2001 Ford Mustang V6-3.8L VIN 4
Vehicle > Technical Service Bulletins

A/T - 4R70W TICKING NOISE IN 1ST GEAR

01-5-8

March 19, 2001

Figure 1

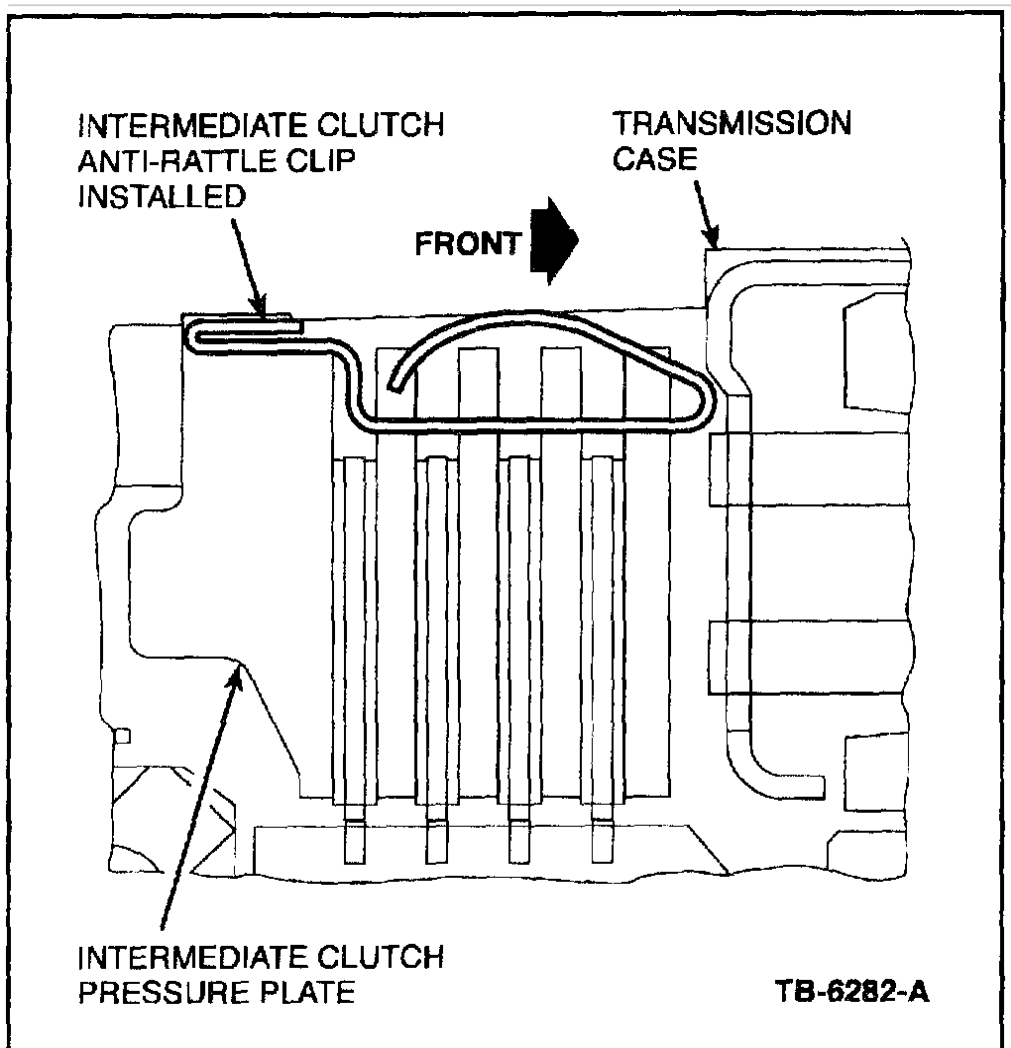
6. Install new Intermediate Clutch Anti-Rattle Clip (YL3Z-7A609-AA) in the center of the 1 o'clock case position. Push clip in until fully seated. (Figures 1 and 2).
7. Check that the intermediate clutch and transmission end clearances are correct. Refer to Workshop Manual, Section 307-01.
8. Install transmission pump assembly using a new Pump Gasket (F2VY-7A1 36-A). Refer to Workshop Manual, Section 307-01.
9. Install the transmission and lower vehicle.
10. Fill transmission to the correct level.
